**TENNESSEE TECHNOLOGY CORRIDOR DEVELOPMENT AUTHORITY**  
**REPORT OF RECOMMENDATION**

**APPEAL OF TTCDA DECISION**

FILE NUMBER: 5-C-22-TOB

A NEW BUILDING FOR  
**HARPER COLLISION**  
 MURDOCK DRIVE  
 KNOX COUNTY, TN  
 TTCDA FILE # 5-C-22-TOB PC # 5-E-22-UR

L100

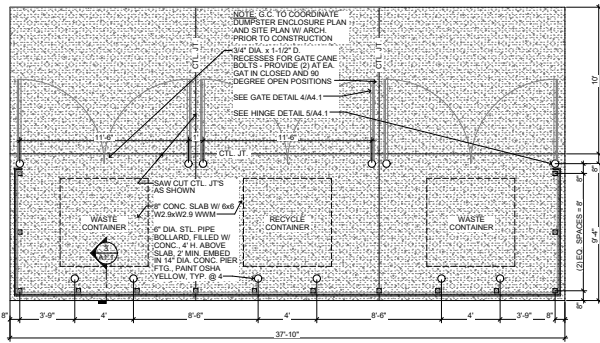
- 1) Reduce the front parking setback to **9 ft** on the eastern edge of the parking lot and 19 ft on the western edge. **Clarification per discussion and consensus at the meeting)**
  - 2) Increase the maximum number of parking spaces allowed to 144 spaces.
-

*Our site has topographic issues and the road is skewed to the parking lot. These two issues make it costly and difficult to comply with the 20' landscape buffer along Murdock Road. The alternatives to the current design would involve reduced parking quantity or moving the building back which would increase the slope height and retaining wall heights on the south side of the development. Therefore we are requesting a waiver to reduce the landscape buffer at the front parking lot to 8' at the eastern edge, and 19' at the western edge as shown on landscape drawing L100.*

- 1) Approve the waiver to reduce the parking lot setback to **9** and **19** ft as requested due to topographic conditions on the site. **(See above)**
- 2) Approve the waiver to increase the number of allowed parking spaces to 144.

[on the eastern edge] and 19 ft [on the western edge] and as such staff is recommending approval of the waiver for 9 and 19 ft. respectively. The staff report will be amended to reflect this. Daniel Sanders, 900 S Gay St, Knoxville, TN 37902, was present. He noted he represented a client who is in opposition and proceeded to express those concerns. Will Robinson, 1248 N. Shorewood Ln., Caryville, TN 37714 reiterated they had a topographic hardship which necessitated the request for the waiver.
